# UNITED STATES PATENT AND TRADEMARK OFFICE

10/816,269

Robert P. Masleid

**Office Action Summary**

FIG. 19(a)

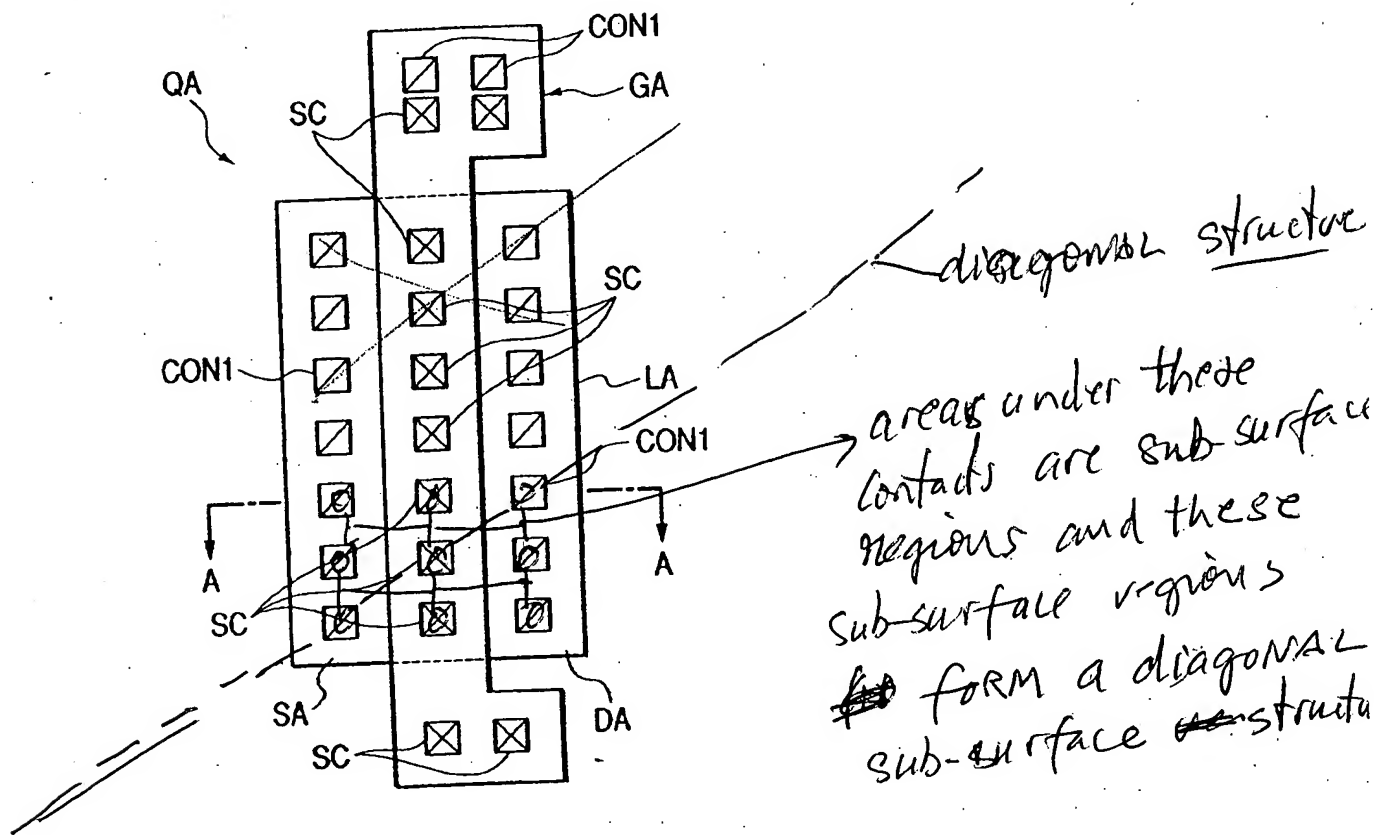
With respect to claim 12, Takahashi et al. further teach the first sub-surface structure is a first diagonal sub-surface mesh structure, and wherein said second sub-surface structure is a second diagonal sub-surface mesh structure. See figs. 19(a) and 20(a).

With respect to claims 2 and 22, Takahashi et al. further teach the sub-surface structure is a diagonal sub-surface mesh structure. See figs. 19(a) and 20(a).

In response to the applicant's arguments in the the paragraph bridging pages 16 and 17 and the first full paragraph on page 17 of the amendment dated 01/24/07, see the attached copy of examiner's explanation and interpretation of figs 19(a) and 20(a) of Takahashi et al.

FIG. 19(b)

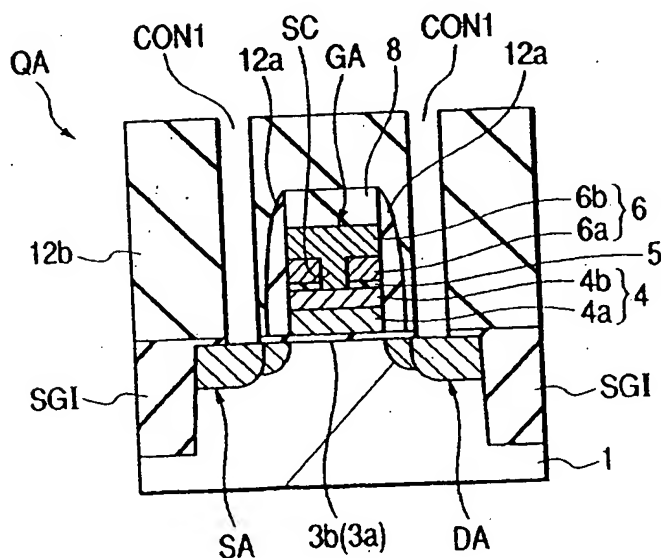
With respect to claims 1 and 21, Takahashi et al. teach a semiconductor device having a surface, comprising (see all disclosed figures, specifically figs. 19(a)-19(b), 20(a)-20(b), and 49 and associated text):

FIG. 49

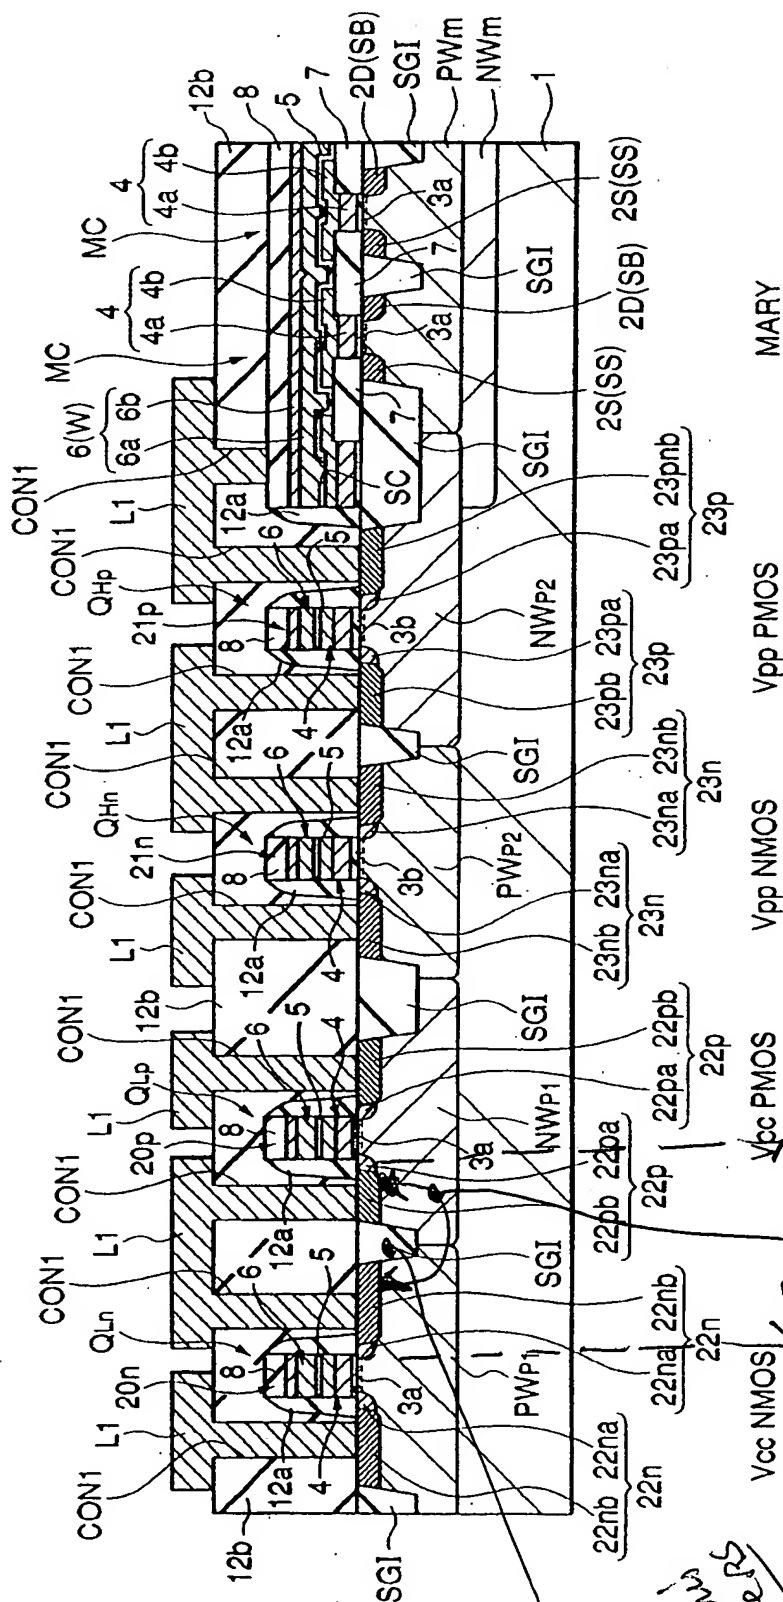
A plurality of conductive sub-surface regions 22nb, 23nb, etc. of a first conductivity each formed beneath said surface **of said semiconductor device**, wherein said conductive sub-surface regions form a sub-surface structure and said sub-surface structure has a perimeter (fig. 49);

With respect to claims 6, 7, 16, 17 26, and 27, Takahashi et al. further teach each conductive sub-surface region has an N-type or P-type doping. See fig. 49.

With respect to claims 8, 18, 28, Takahashi et al. further teach each conductive sub-surface region has a strip shape. See fig. 49.

With respect to claims 10, 20, 32, Takahashi et al. further teach a plurality of second conductive sub-surface regions 23nb of said first conductivity each formed under each portion of said metal structure that overlaps said sub-surface structure, wherein each second conductive sub-surface region has a continuous sub-surface layer shape. See fig. 49.

With respect to claims 35, 40, and 45, Takahashi et al. further teach that the plurality of conductive sub-surface regions would inherently prevent the isolation of wells (PWp1, NWp1, PWp2, NWp, etc) 2of the semiconductor device since they provide conductive path. See figure 49.

With respect to claims 37, 42, and 47, Takahashi et al. further teach that the isolation structure SGI creates a gap that separates the conductive sub-surface regions to at least two regions. See figure 49.

In response to the applicant's arguments in the first and second full paragraphs on page 14 of the amendment dated 01/24/07, see the attached copy of examiner's explanation and interpretation of fig. 49 of Takahashi et al.

In response to the applicant's arguments in the paragraph at the bottom of page 14 of the amendment dated 01/24/07, it is submitted that Takahashi et al. further teach a plurality of second conductive sub-surface regions 23nb of said first conductivity each formed under each portion of said metal structure that overlaps said sub-surface structure, wherein each second conductive sub-surface region has a continuous sub-surface layer shape. See fig. 49.

subregions or sub-surface structures  
 defined by sketch  
 sub-surface structures
